UNITED STATES PATENT AND TRADEMARK OFFICE

APPLICATION NO.	FILING DATE	FIRST NAMED INVENTOR	ATTORNEY DOCKET NO.	CONFIRMATION NO.
09/785,456	02/20/2001	Hwan-Seong Yu	8733.394.00	5029

Office Action Summary

2. **Claims 1-35 are rejected under 35 U.S.C. 103(a) as being unpatentable over applicant's admitted prior art (AAPA) in view of Toshio et al., (Toshio), JP 2-210402.**

第 4 図

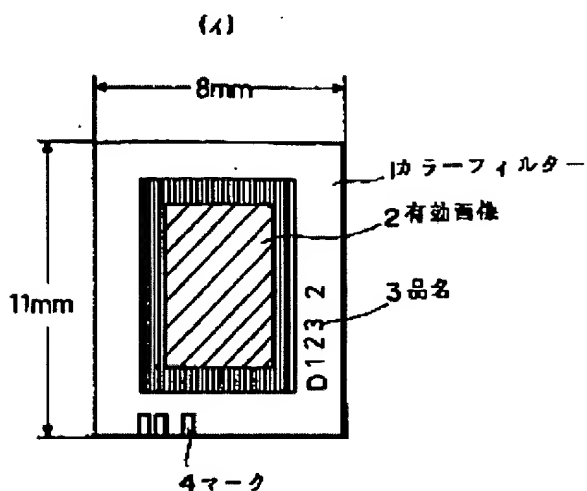
Toshio discloses color filters with identification mark. Toshio also discloses that by providing identifiable codes/marks in the non-effective image areas of the filters (applicant's periphery of the substrate), it is possible to eliminate the generation of defects and identification errors in the identification work (abstract; Fig. 4).

As to claims 5-7 and 21-23, Toshio shows in Fig. 4 that the identification mark includes a sign and a character wherein the character includes an alphabet and a number.

Further, for the sake of applicant's argument, it is respectfully pointed out to applicant that Toshio et al., indeed discloses the black matrix being formed at the periphery of the substrate (col. 4, lines 1-2). As a matter of fact Toshio et al., discloses that light shielding layer is formed along with the color filter and as shown in Fig. 4, the color filter (1) is formed at the periphery of the substrate. Therefore, it is clear that the black matrix (not shown in Fig. 4 of Toshio) has a pattern on the substrate and an identification mark (shown in Fig. 4) corresponding to the pattern of the black matrix is formed at a periphery of the substrate.
